SUMMARY OF AA-1 SERVICE LETTERS

SERVICE

L
E
T
T
E
R

Figure 1. Improved Anti-shimmy Washer Installation

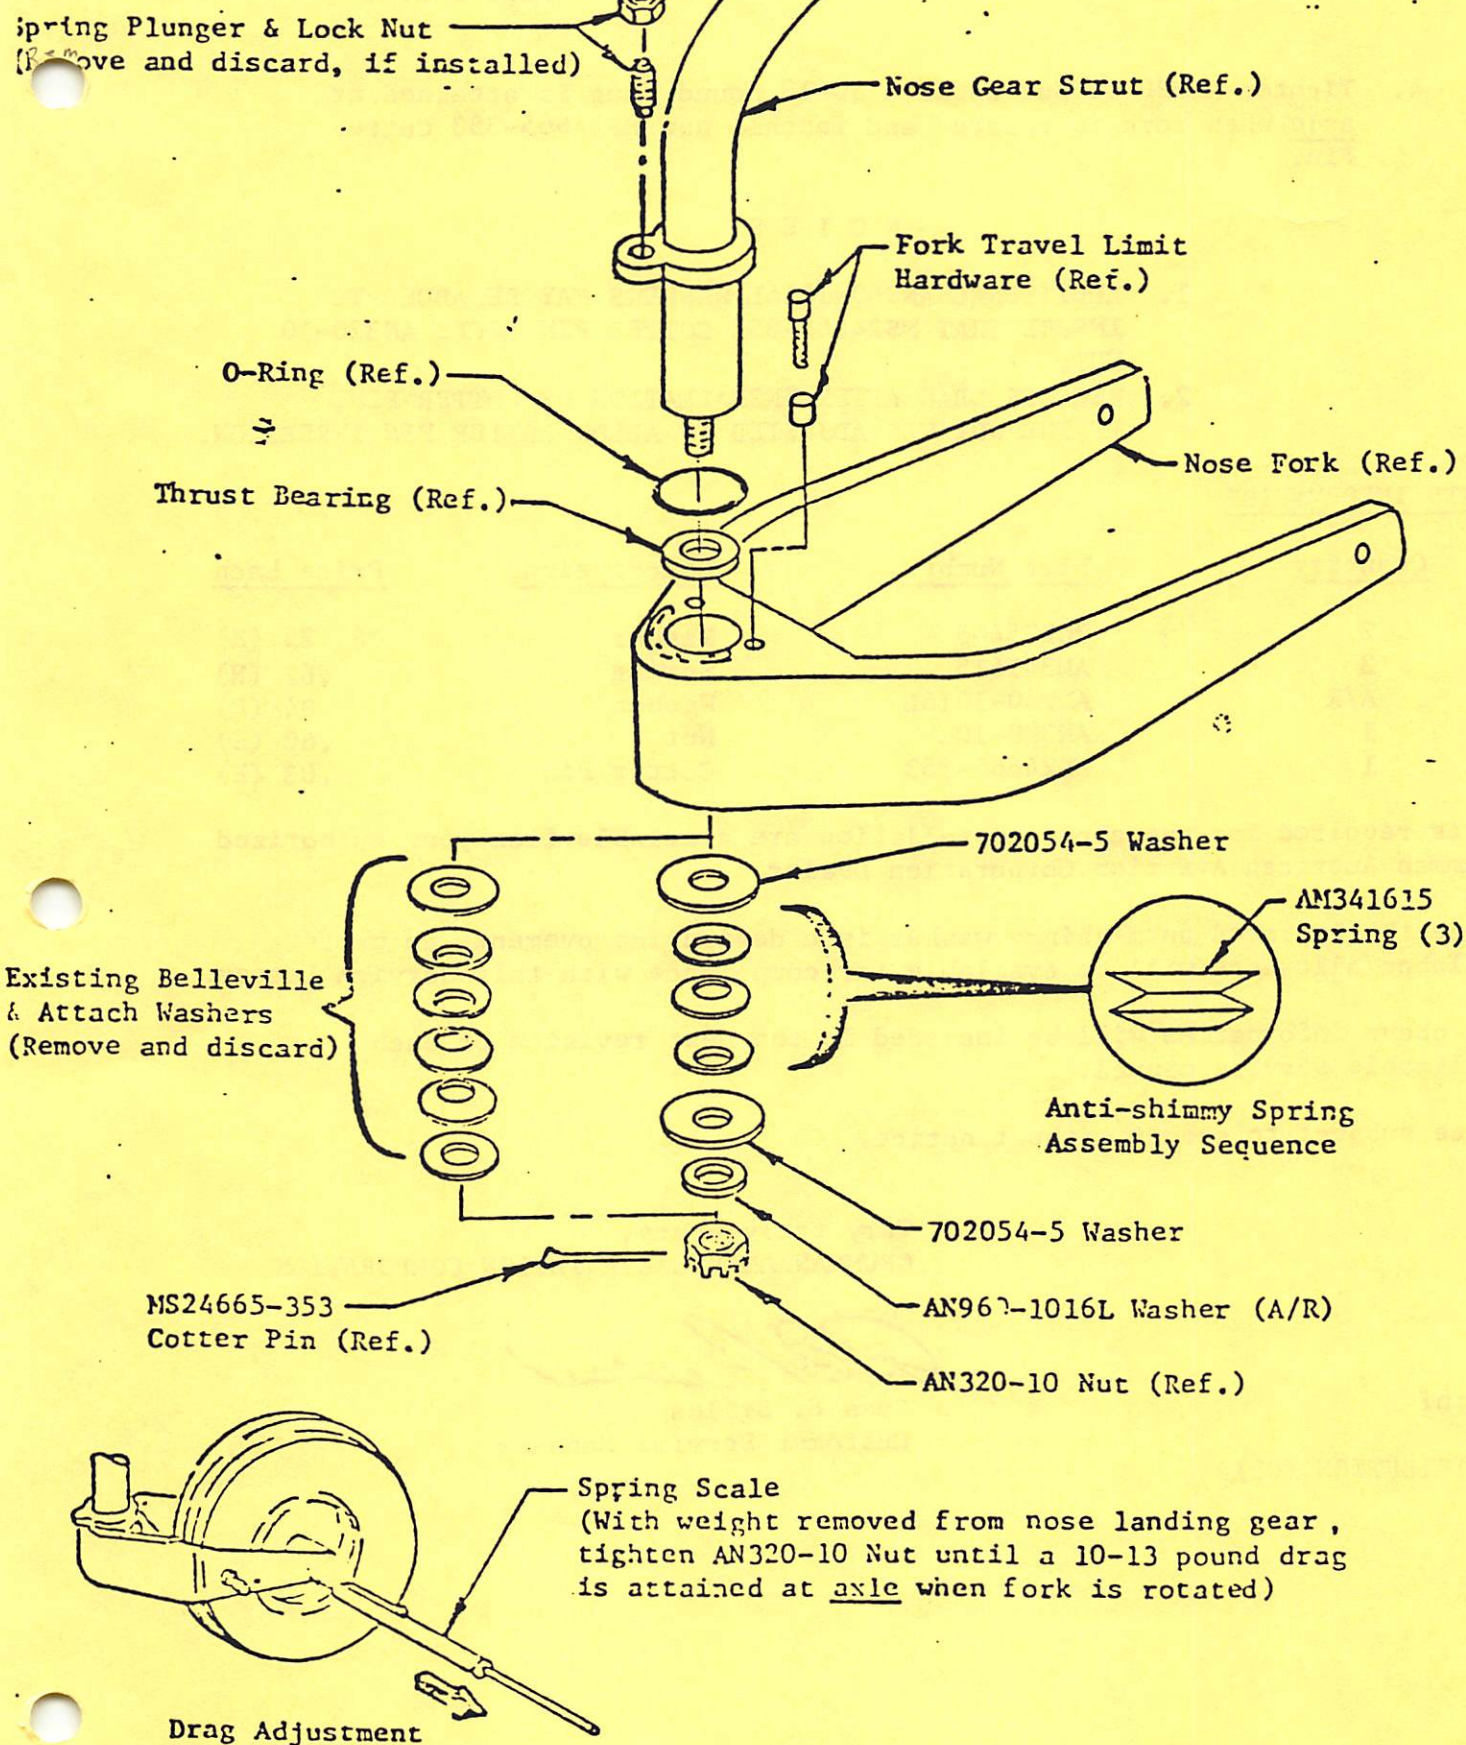
1. Remove weight from the nose landing gear per jacking instructions in the applicable service manual.
2. Remove MS24665-353 Cotter Pin and AN320-10 Nut that attaches nose fork to nose gear strut and discard existing Belleville and attach washers.
3. Assemble 702054-5 Washers, AM341615 Springs, AN960-1016L Washers and AN320-10 Nut in the order shown in Figure 1 and attach to nose gear strut.

Figure 1. Parking Brake Improvement

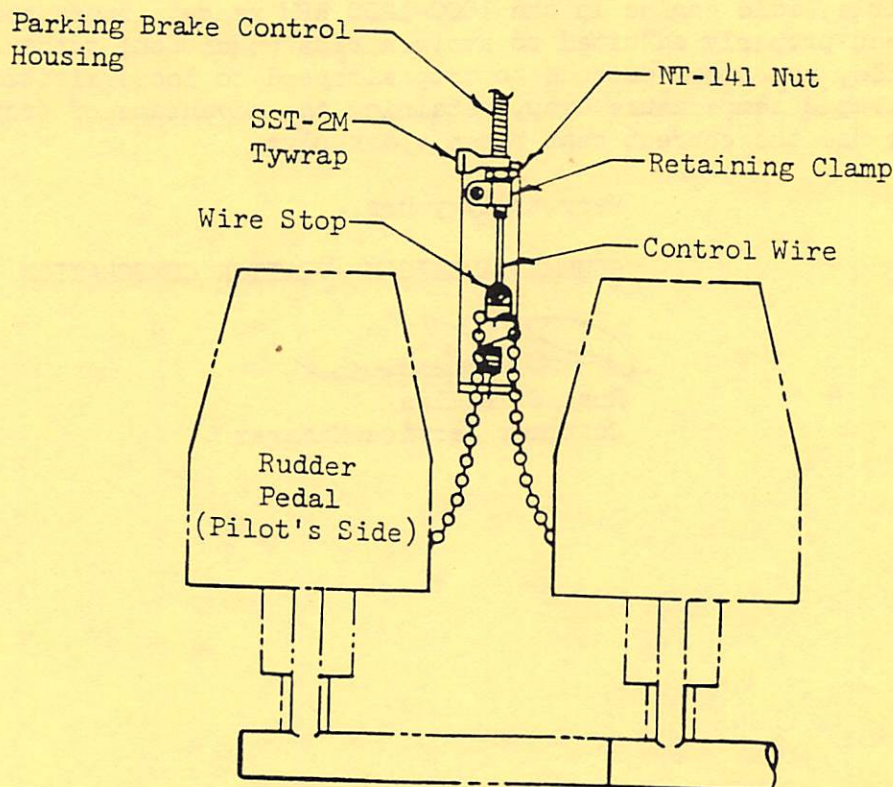
1. Loosen screw on wire stop, straighten parking brake control wire and remove wire stop.
